FINAL PRODUCT/PROCESS CHANGE NOTIFICATION

SUBJECT: ON Semiconductor Final Product/Process Change Notification #16218

TITLE: TSSOP Tube Dimension change: Tube width from 6.858mm to 8.44mm and Pedestal height from 1.397mm to 1.55mm

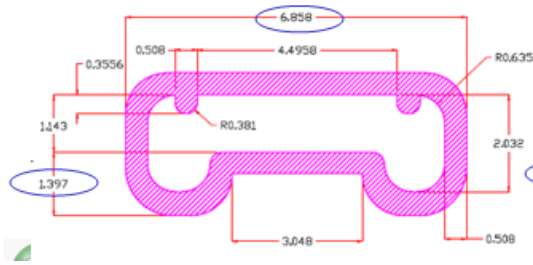
ON Semiconductor is notifying customers of its TSSOP Tube Dimension change.

NX Tube-to-Tube process is horizontal off-loading thus blowing units inside the tube is required. Package guided tube is needed to avoid leads from hitting the tube wall. New tube dimension is more robust thus allowing more clearance between leads and tube wall (Quality Improvement). Wall thickness improved by 0.1mm to make it stiffer for better alignment with respect to the machine track.
